Access Compliance Report

Public Rights-of-Way

Intersection ID: 7648	Main Street: STARITA_RD	Cross Street: WOODPARK_BV	Location: SE
ADA ID: 2856AF51E122	Ramp Type: Perp	Initial Pass/Fail: Fail	Overall Compliance: No
		Severity Score: 1.25

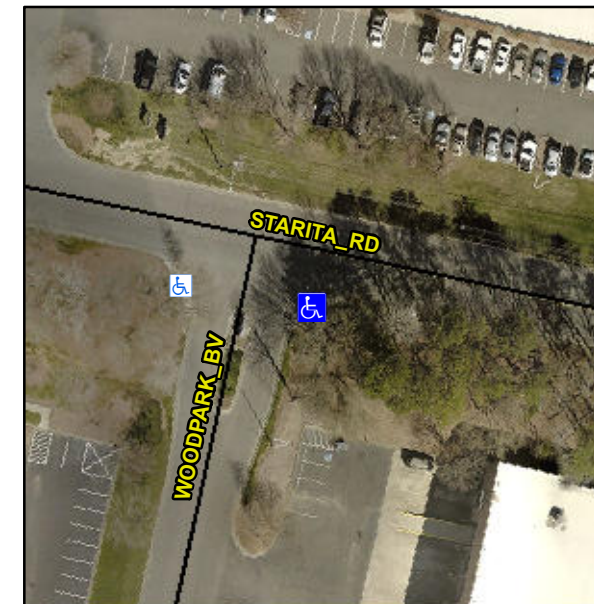
Not Found, R304.5.3

Compliance	Description	Data	Compliance	Description	Data
N/A	Ramp Length (in)	62.0	Yes	Ramp Slope (%)	8.0
Yes	Ramp Width (in)	60.0	No	Ramp XSlope (%)	3.0
N/A	Flare Type LT	N/A	N/A	Flare Type RT	N/A
N/A	Flare Slope LT (%)	N/A	N/A	Flare Slope RT (%)	N/A
N/A	Flare Traversable LT?	N/A	N/A	Flare Traversable RT?	N/A
N/A	Landing Length (in)	N/A	N/A	DWS Provided?	N/A
N/A	Landing Width (in)	N/A	N/A	DWS Contrast?	N/A
N/A	Landing Slope (%)	N/A	N/A	DWS Length (in)	N/A
N/A	Landing X Slope (%)	N/A	N/A	DWS Full Width?	N/A
N/A	Landing Curb? (Y/N)	N/A	N/A	DWS Offset (in)	N/A
N/A	Shared Landing?	N/A			
N/A	Gutter Ponding?	N/A	N/A	Gutter Slope (%)	N/A
N/A	Gutter Lip Ht (in)	N/A	N/A	Gutter X Slope (%)	N/A
N/A	Painted X Walk1?	No	N/A	Painted X Walk2?	N/A
	X Walk 1 Direction	To NW		X Walk 2 Direction	N/A
N/A	X Walk 1 Width (in)	N/A	N/A	X Walk 2 Width (in)	N/A
	X Walk 1 Slope (%)	1.0		X Walk 2 Slope (%)	N/A
	X Walk 1 X Slope (%)	7.4		X Walk 2 X Slope (%)	N/A

Remove & Replace Entire Ramp.
